**SOUTHERN CALIFORNIA EDISON'S  
SAN JOAQUIN CROSS VALLEY LOOP  
220 KV TRANSMISSION LINE PROJECT**

**CPUC A.08-05-039**

Final Environmental Impact Report  
(Response to Comments)

Prepared for:  
California Public Utilities Commission

Figure 4. Alternative 3 Road Story, Page 19, with Reroute Marked in Red

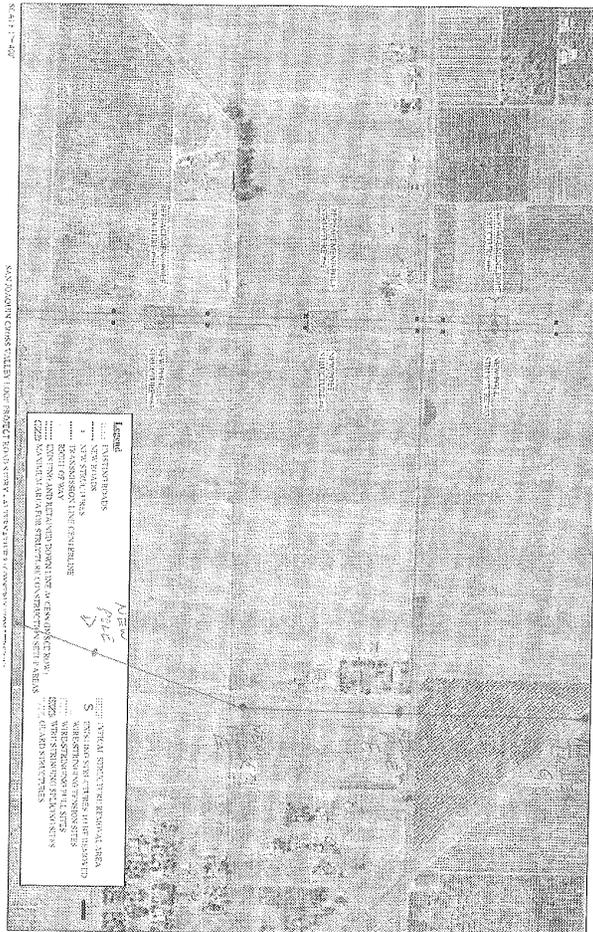
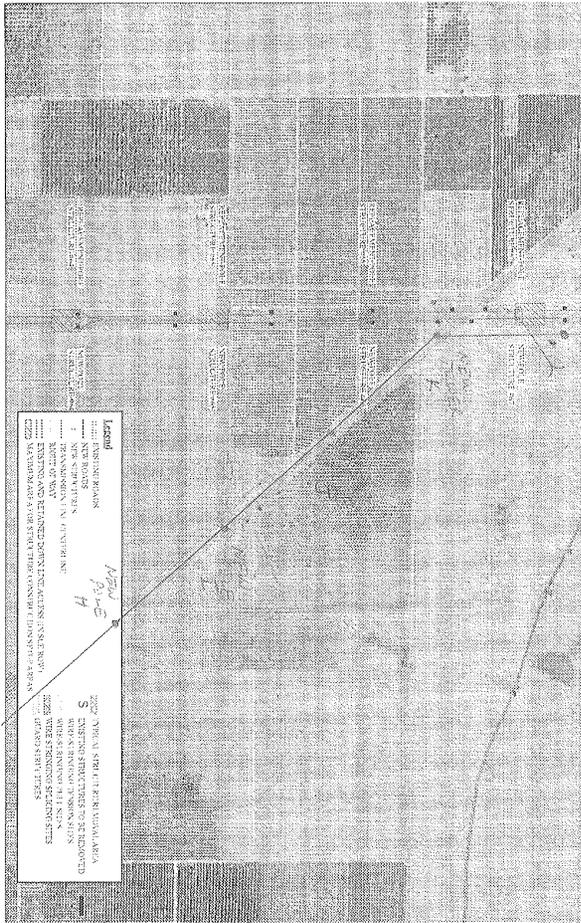
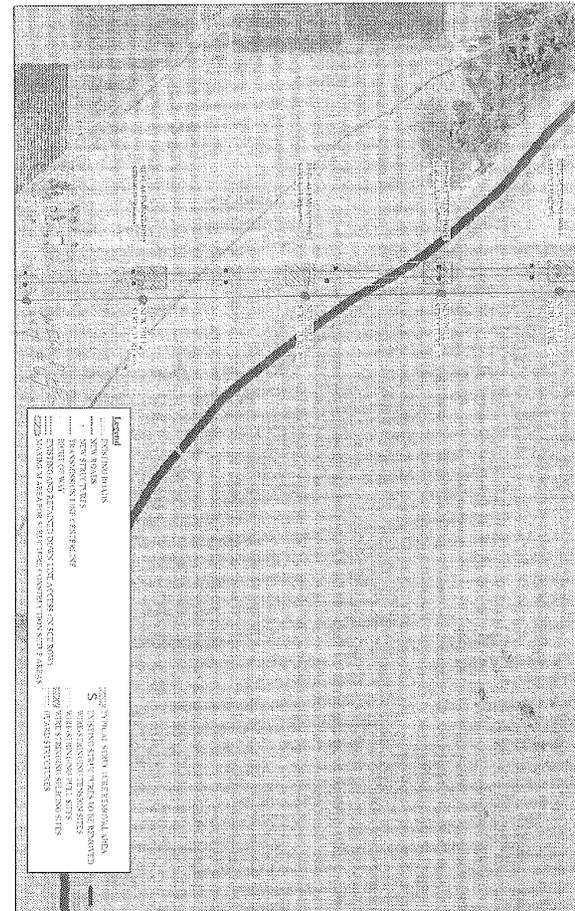
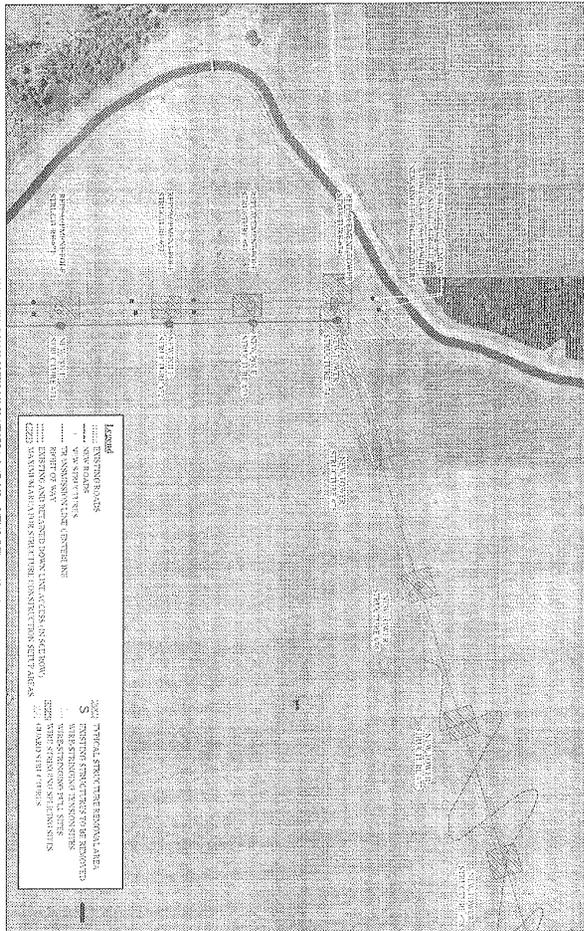
Preliminary tower spotting for the Alternative 3A reroute is shown in Figures 3 through 7. The preliminary tower spotting uses span lengths between structures similar to those used in the preliminary tower spotting for the alternative routes presented in Section 2 and Appendix C of the draft Environmental Impact Report. Figures 3 through 7 are black and white copies of Pages 18 through 22 of the Alternative 3 Road Story<sup>6</sup> respectively with the Alternative 3A preliminary line reroute centerline, towers and poles marked in red. The new Alternative 3A reroute structures added to bypass the Stone Corral ecological reserve are labeled alphabetically to differentiate them from the existing Alternative 3 structures passing through the reserve.

Figure 3 shows Alternative 3A replacement pole structure #58 and new pole structure #58 replaced with dead end double circuit tower structures relocated South of Avenue 376. The two existing Big Creek – rector 220 kV lines will transition to double circuit configuration at the relocated replacement tower structure #58. The new double circuit San Joaquin cross valley loop transmission line exits the existing right of way, proceeding easterly to a new tower structure A. All construction associated with the placement of these towers, transitioning the existing Big Creek – rector lines to double circuit configuration, and conductor stringing will be located East of Road 144 and South of Avenue 376, which is outside the Stone Corral Ecological Reserve.

Figure 5 shows the Alternative 3A cross valley loop reroute preliminary tower spotting from new tower structure G along the abandoned railroad right of way to the next point of intersection, tower structure K located adjacent to the existing Big Creek – Rector lines, using three tangent pole structures, H, I and J.

Figures 5, 6 and 7 show the Alternative 3A cross valley loop reroute preliminary tower spotting from new tower structure K proceeding north adjacent to the existing Big creek – Rector lines to the next point of intersection, new tower structure #74, using seven tangent pole structures, #67 through #73. This tower spotting is similar to the preliminary Alternative 3 tower spotting, but located adjacent to the existing Big Creek – Rector 220 kV transmission lines, which will remain undisturbed.

Figures 3 through 7 also show that 24 Alternative 3 structures, replacement structures #59 through #74 and new structures #59 through #66, will not be needed if the proposed preliminary Alternative 3A reroute is employed. These changes are marked in green.

Figure 5. Alternative 3 Road Story, Page 20, with Reroute Marked in Red

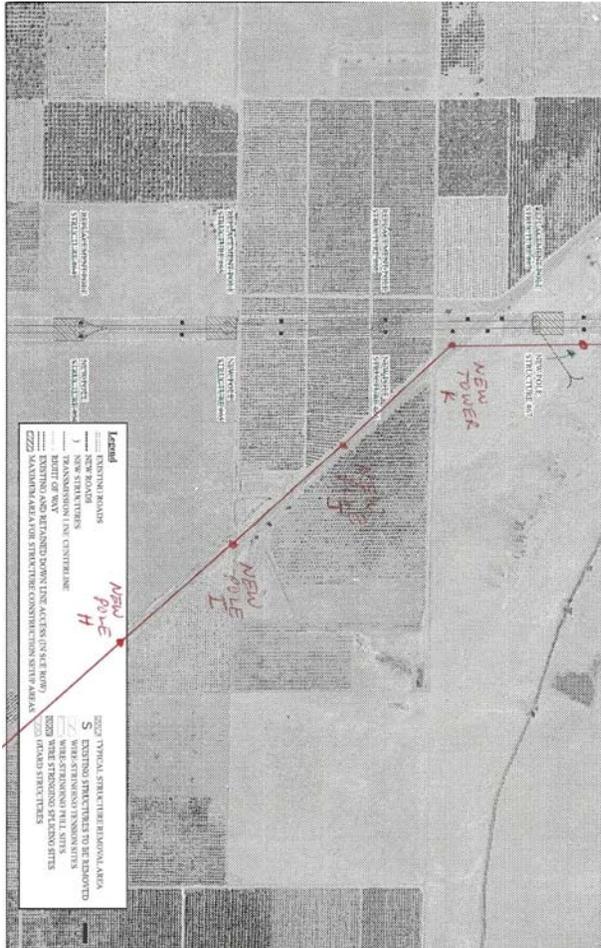
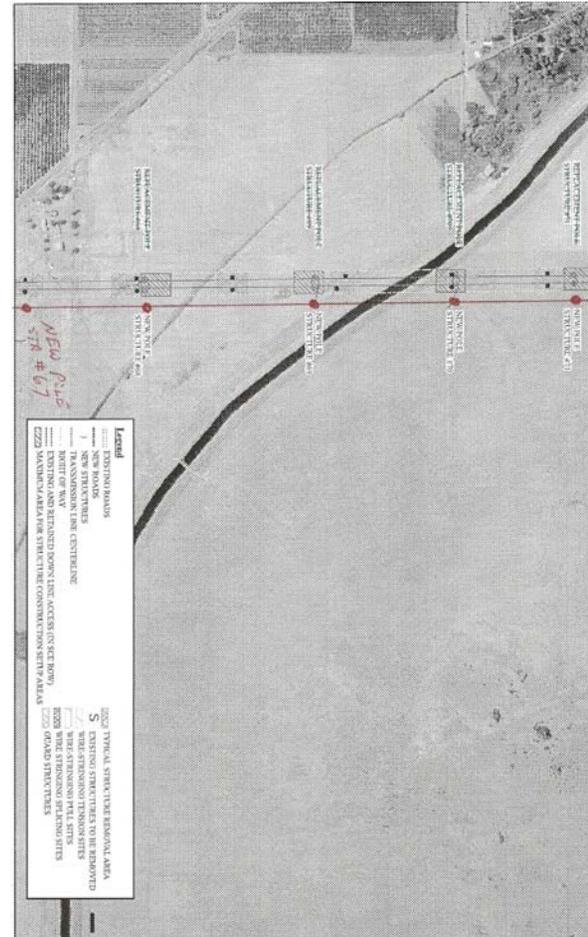
Figure 5 shows the Alternative 3A cross valley loop reroute preliminary tower spotting from new tower structure G along the abandoned railroad right of way to the next point of intersection, tower structure K located adjacent to the existing Big Creek – Rector lines, using three tangent pole structures, H, I and J.

Figures 5, 6 and 7 show the Alternative 3A cross valley loop reroute preliminary tower spotting from new tower structure K proceeding north adjacent to the existing Big creek – Rector lines to the next point of intersection, new tower structure #74, using seven tangent pole structures, #67 through #73. This tower spotting is similar to the preliminary Alternative 3 tower spotting, but located adjacent to the existing Big Creek – Rector 220 kV transmission lines, which will remain undisturbed.

Figures 3 through 7 also show that 24 Alternative 3 structures, replacement structures #59 through #74 and new structures #59 through #66, will not be needed if the proposed preliminary Alternative 3A reroute is employed. These changes are marked in green.

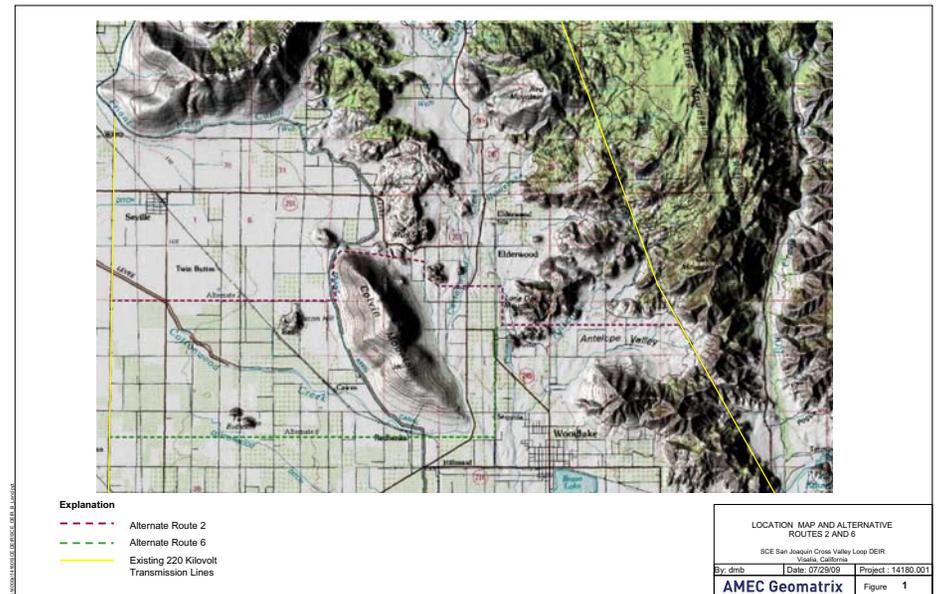
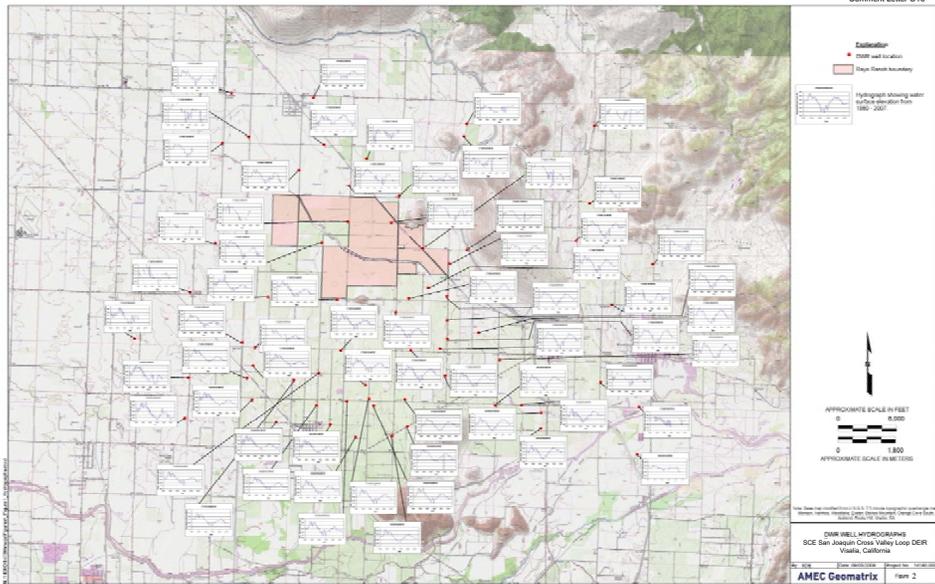
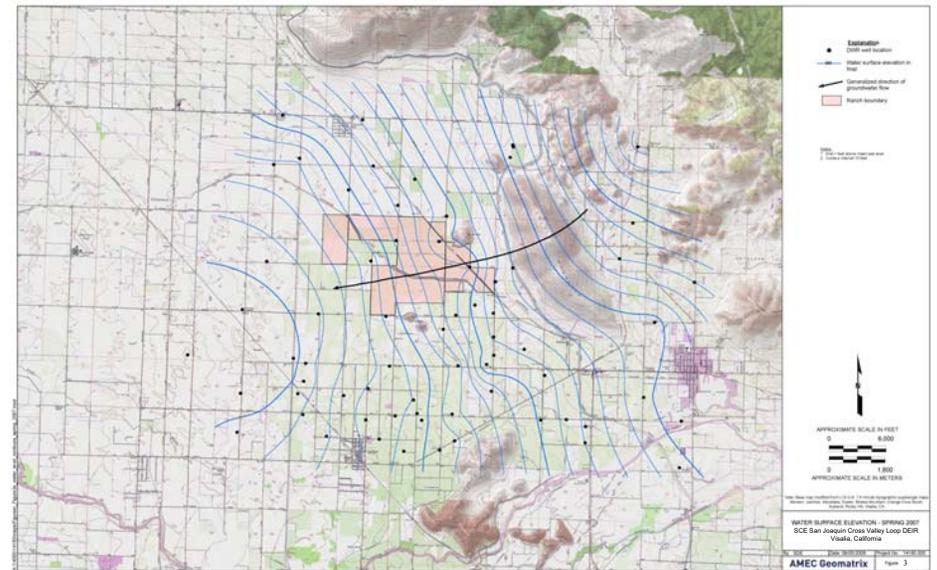
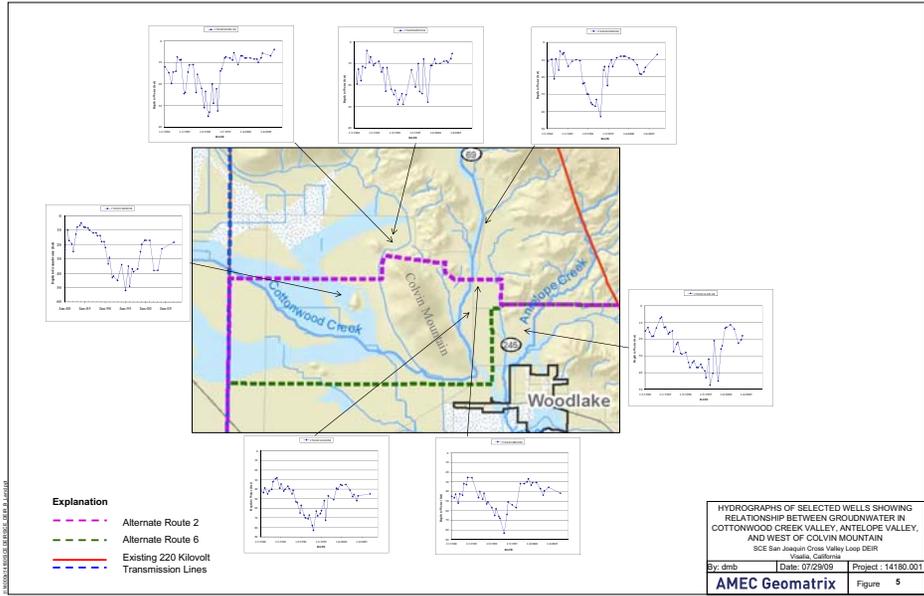
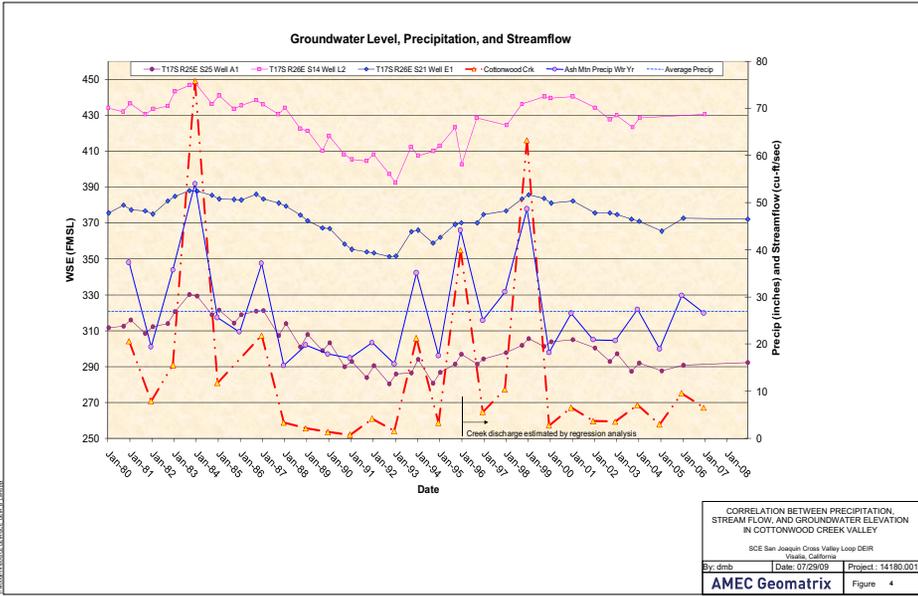
Groundwater elevation data collected by the California Department of Water Resources (DWR) and the United States Geological Survey (USGS) were used to prepare long-term hydrographs from 1980 to 2007 for over 60 wells in the area (Figure 2). Some of our more important observations are:

- Groundwater flows generally from east to west from the foothills areas (i.e. Cottonwood Creek drainage and Antelope Valley) to the Valley trough west of Highway 99 (Figure 3).
- The groundwater gradient is consistent in direction and magnitude during both Fall and Spring and during wet and dry periods.

In summary, the DEIR is deficient because of the following:

- The DEIR comparison of potential groundwater impacts from the various alternatives is deficient.
- The DEIR fails to acknowledge the risks of construction on groundwater recharge and resources in the foothill areas of Alternative Routes 2 and 6.
- The DEIR also fails to acknowledge the risks of construction of roads and foundations to existing water supply wells in the shallow alluvium and fractured bedrock aquifers beneath Alternative Routes 2 and 6.

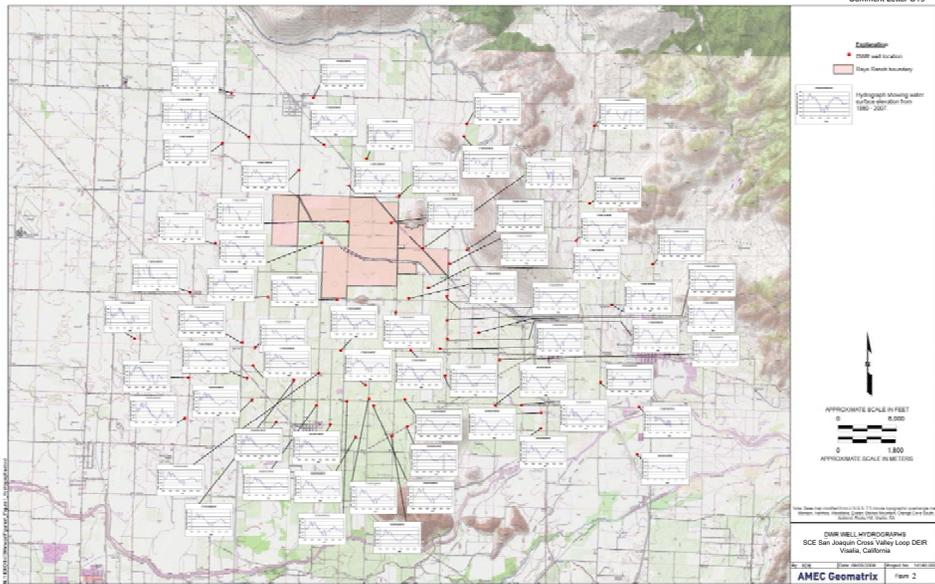
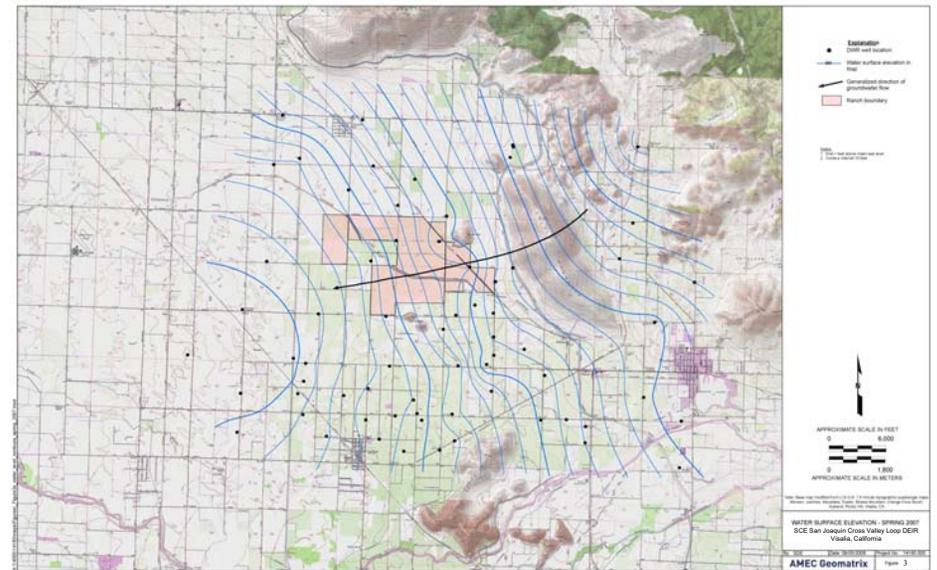
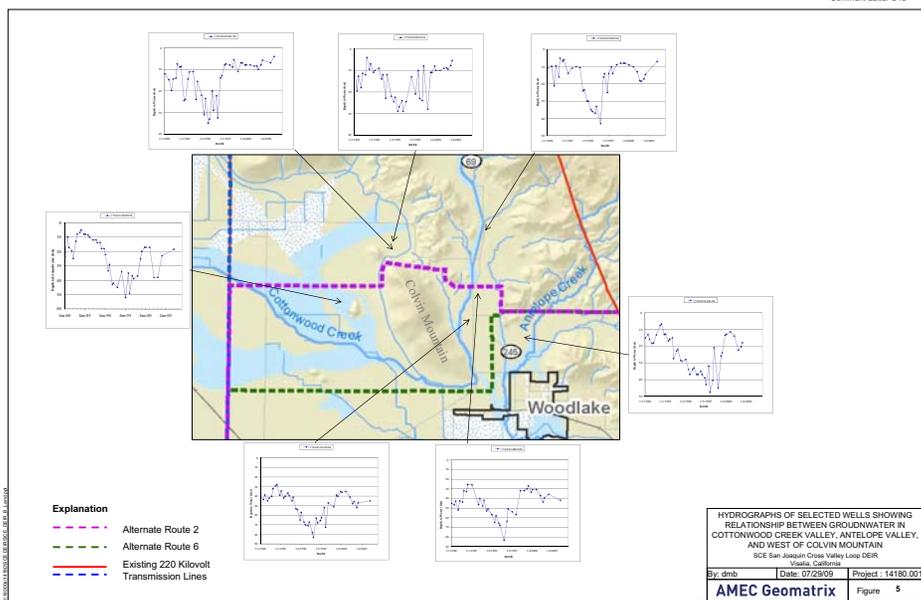
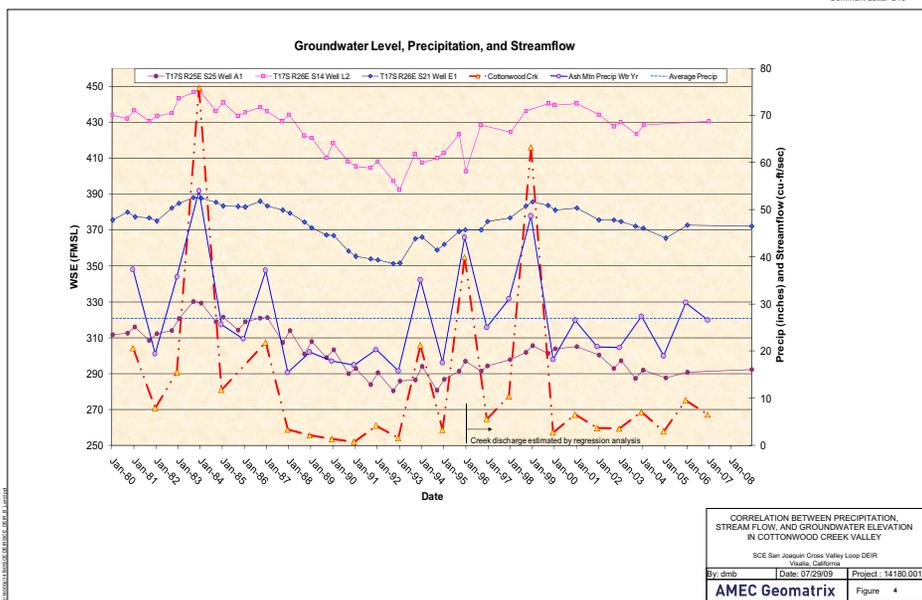
Groundwater elevation data collected by the California Department of Water Resources (DWR) and the United States Geological Survey (USGS) were used to prepare long-term hydrographs from 1980 to 2007 for over 60 wells in the area (Figure 2). Some of our more important observations are:

- Groundwater flows generally from east to west from the foothills areas (i.e. Cottonwood Creek drainage and Antelope Valley) to the Valley trough west of Highway 99 (Figure 3).
- The groundwater gradient is consistent in direction and magnitude during both Fall and Spring and during wet and dry periods.

**Figure 4.1-11a and 4.1-11b**  
Visual Simulation of Project Site

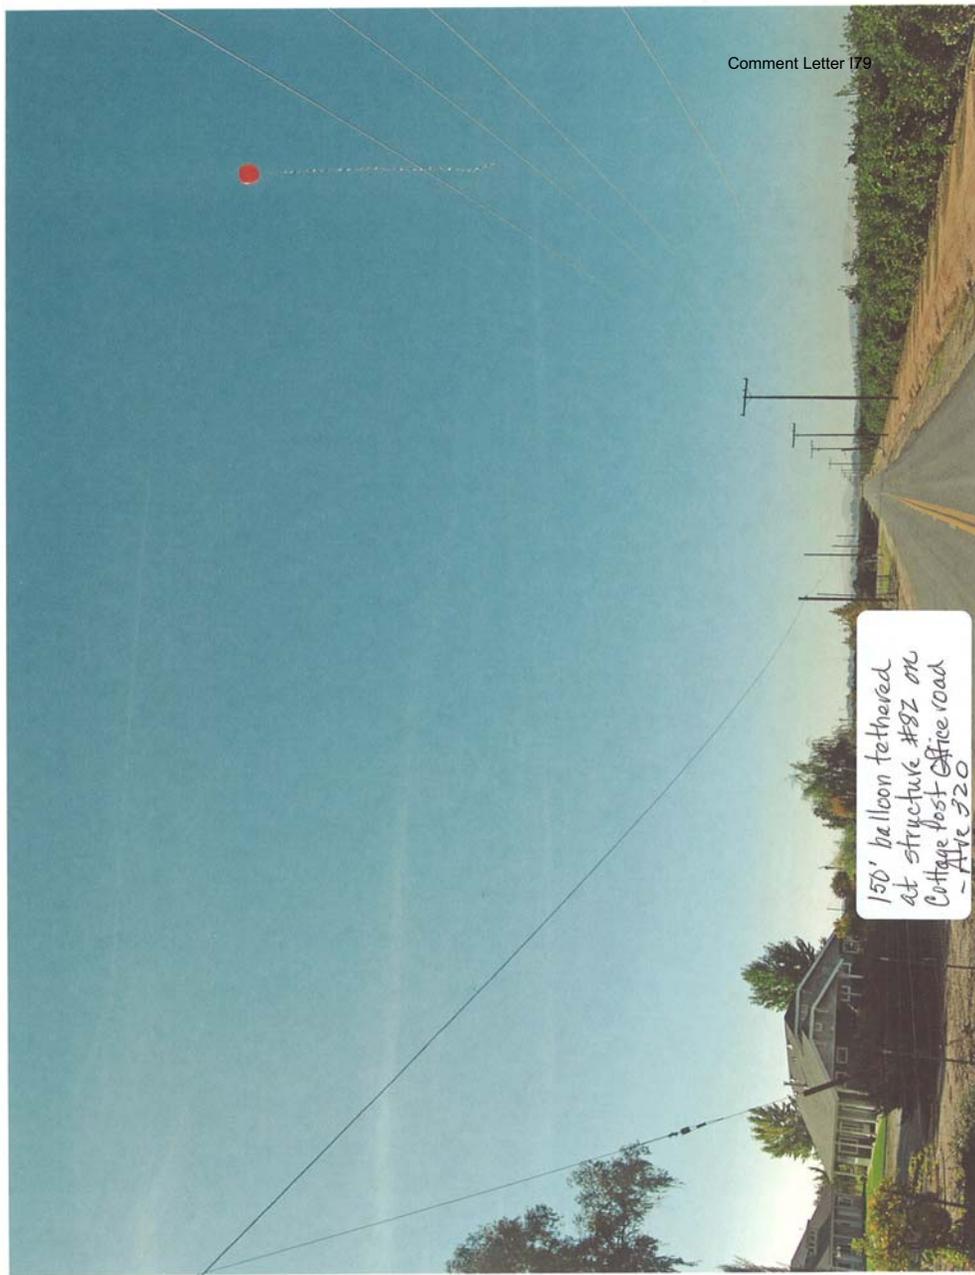
Curious about just how high a 120’-160’ pole might be, we tethered a helium-filled balloon on a 150 foot line from the exact location of the proposed pole identified as Structure 82 in the Road Story illustrations. It’s humongous! “Attachment B” Includes a picture we took of the balloon and several corrected versions of Figure 4.1-11b.

150' balloon tethered  
at structure #82 on  
Cottage Post Office road  
- Ave 320
